COMMITTEE OF THE WHOLE JUNE 20, 2005

**ZONING BY-LAW AMENDMENT FILE Z.03.015
SITE DEVELOPMENT FILE DA.04.023
JANE-RUTH DEVELOPMENT INC.**

Site Plan - Building 'A'

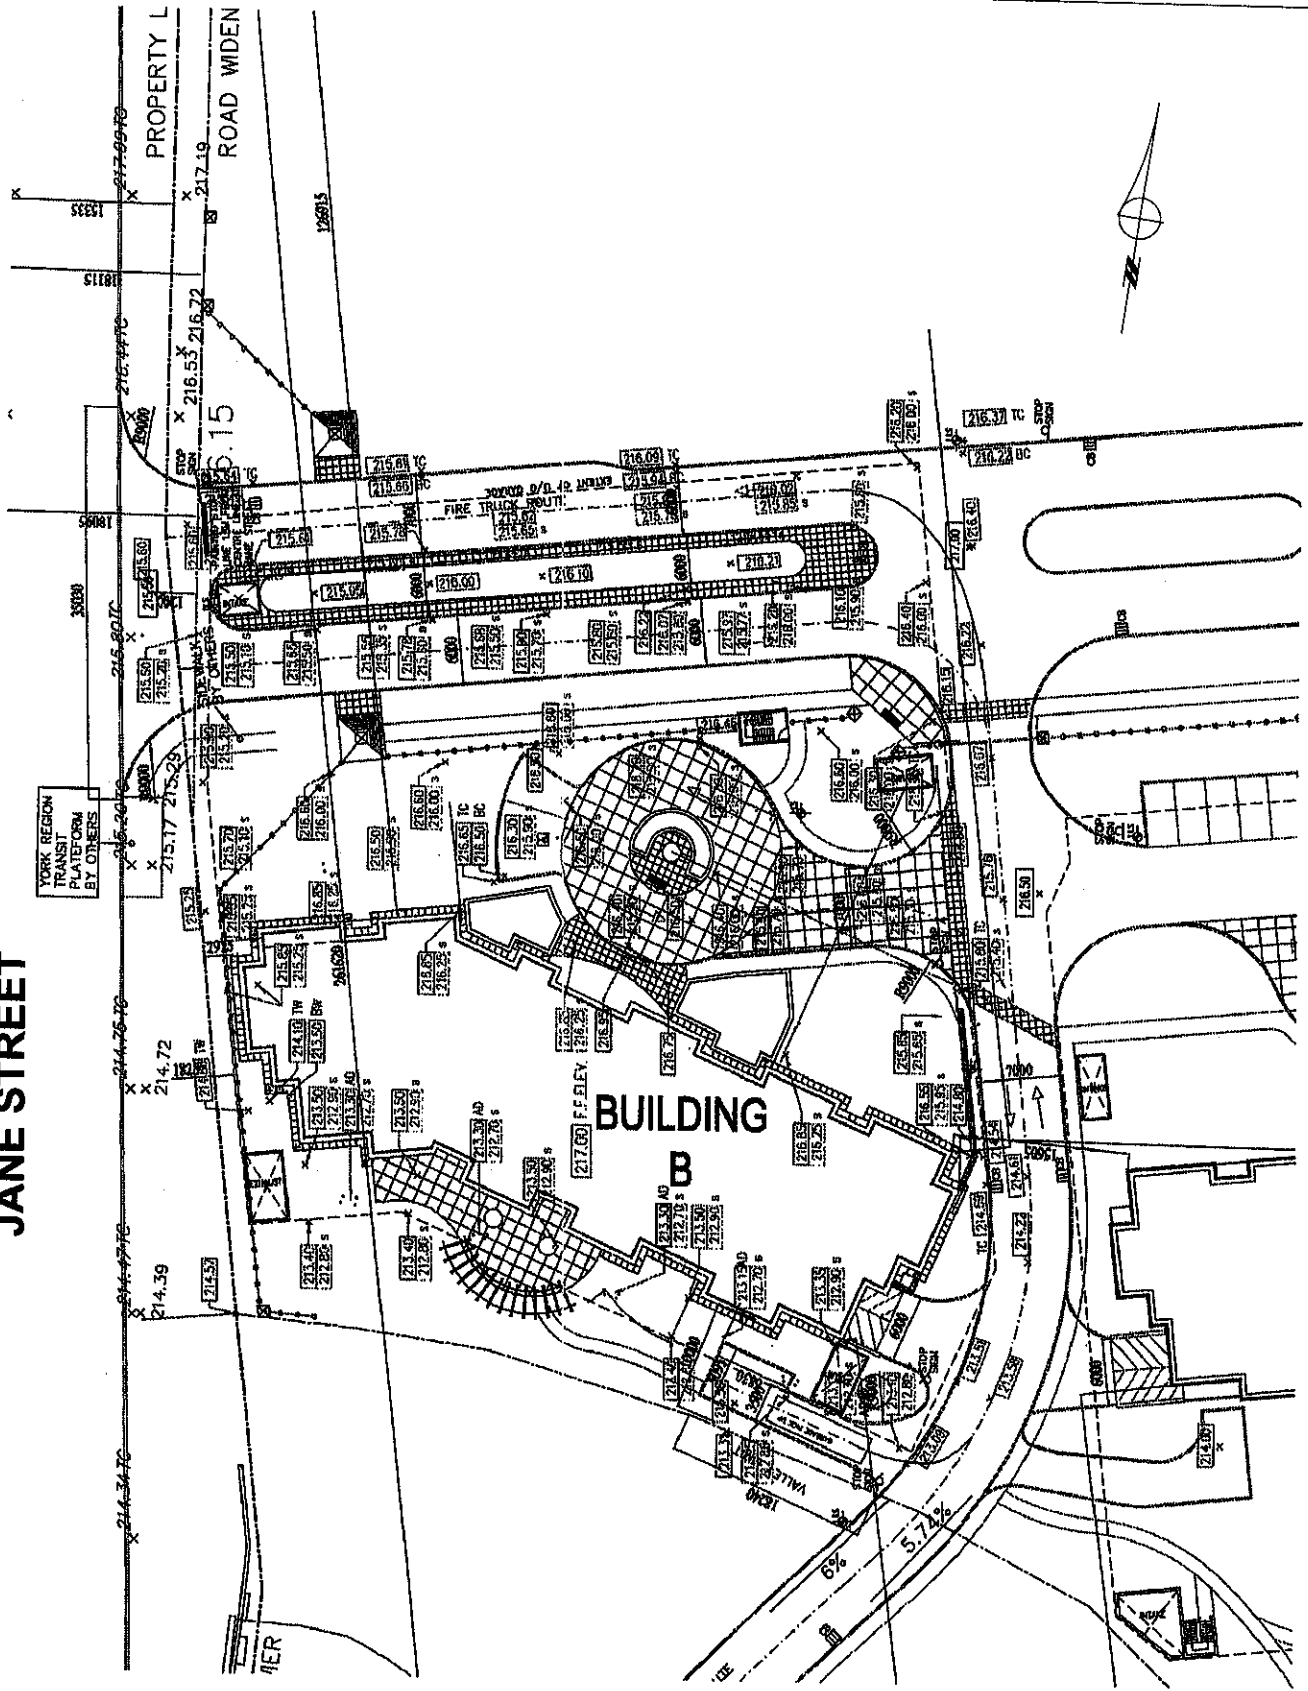
The current site plan application will facilitate the development of Buildings "A" and "B" only. Building "A" is located at the northeast corner of Jane Street and Rutherford Road and setback from the street as directed in the OMB Decision Order. An internal driveway is located between the building and the arterial roads, which connects to the development north of the valley lands. A roundabout is located in front of the main entry of the building to provide a convenient drop off area for residents and visitors. Fifteen grade level parking spaces are provided opposite the main entrance off the internal road. Otherwise, all of the parking for Building "A" is located in an underground garage accessed via a driveway from the main internal road. The area between the internal access road and the arterial roads is landscaped and incorporates a large circular design feature anchoring the project at the corner. The garbage pick-up area is located on the north side of Building "A".

Staff has discussed with the applicant the option of providing an enhanced architectural treatment for the driveway ramps leading to the underground parking facility in the form of a projecting canopy or other light structure that encloses a significant portion of the access throat into the parking area, which is not incorporated on the current submission. Staff recommends that the applicant review this issue with Staff, prior to final site plan approval.

Site Plan - Building 'B'

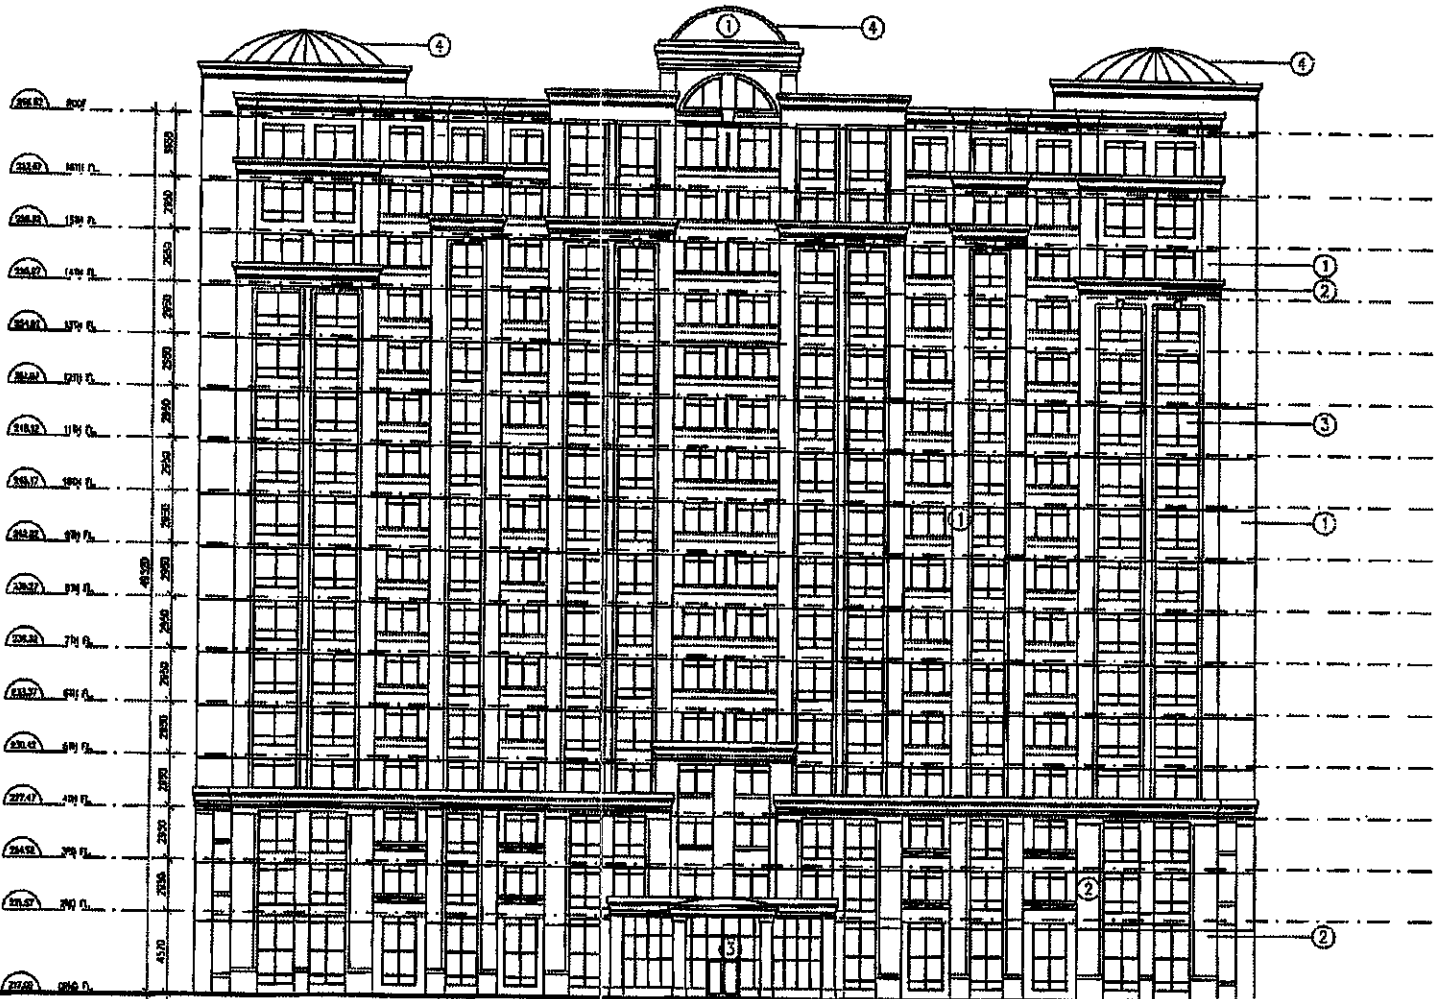
The visitor parking supply for Building "B" is deficient by 1 parking space, however, there is a surplus of resident parking spaces, one of which, can be converted to a visitor parking space and satisfy the minimum parking requirements of By-law 1-88. A four level underground parking garage is proposed for each building to accommodate the required parking spaces. The applicant will be required to show the location of the handicapped parking sign and to post it in front of these spaces.

- the requirements for Regional Road widening and reserves;
- Building "B" must be located to comply with the minimum setback to the widened Regional right-of-way as required by the Region;
- the access to the commercial lands will likely be restricted to a right-in/right-out configuration;
- a number of design related matters respecting the configurations of the access driveway to Rutherford Road and Jane Street; and,
- the Owner must submit a Noise Study for the Region's review.

Master Landscape Plan

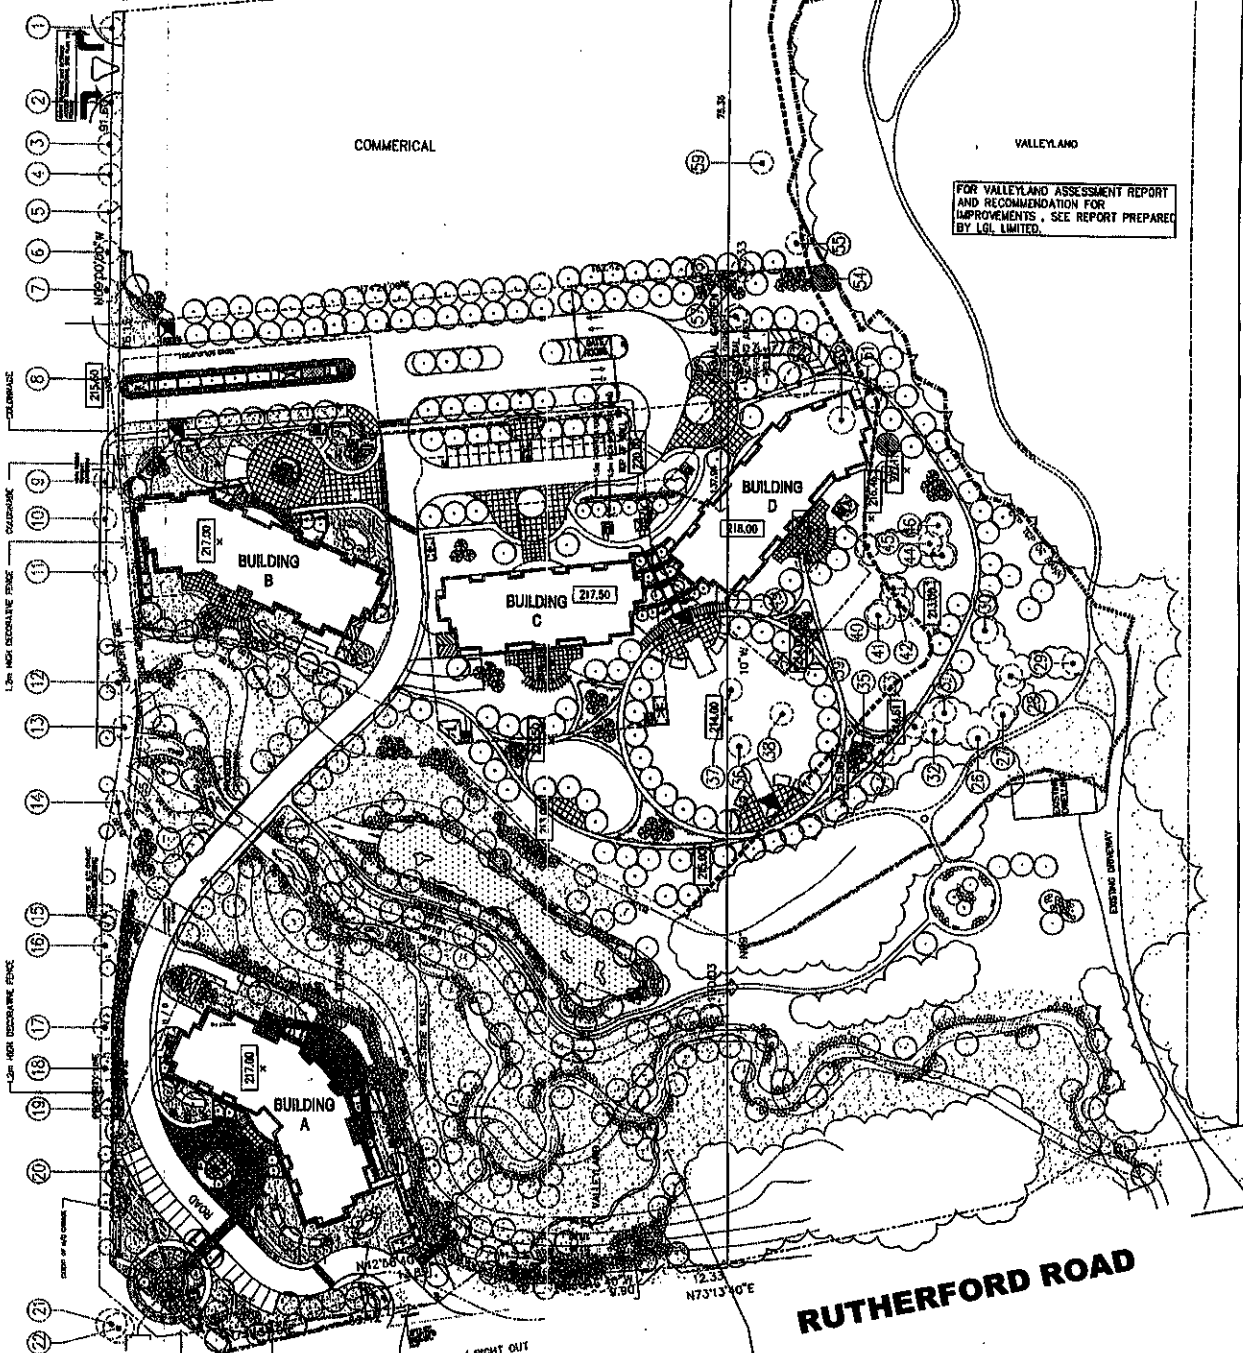
The Owner has submitted a Master Landscape Plan and Tree Inventory and detailed landscaping/planting plans for the proposed development as shown on Attachments #11, #12, #13 and #14. The landscape plans consist of a mix of coniferous and deciduous trees and ground plantings utilized along the street frontages, around each building and abutting the valley lands. The plans also illustrate proposed hard surfaced landscape areas including walkways and amenity areas. The plan includes a landscape feature on the northeast corner of Jane Street and Rutherford Road consisting of plant material, and a corner colonnade as shown on Attachment #15. The colonnade has a circular design and is constructed with precast concrete beams, a wood trellis and iron fencing. Benches, landscaping, lighting and a sculpture will be provided within this area and will function as an amenity area for the development. It is noted that a portion

of this area encroaches into the Regional road right-of-way and therefore, Region of York approval is required.

Staff has reviewed the landscape plans and is generally satisfied with the proposed landscape treatment. The landscape cost estimate shall also be revised to reflect current market replacement costs.
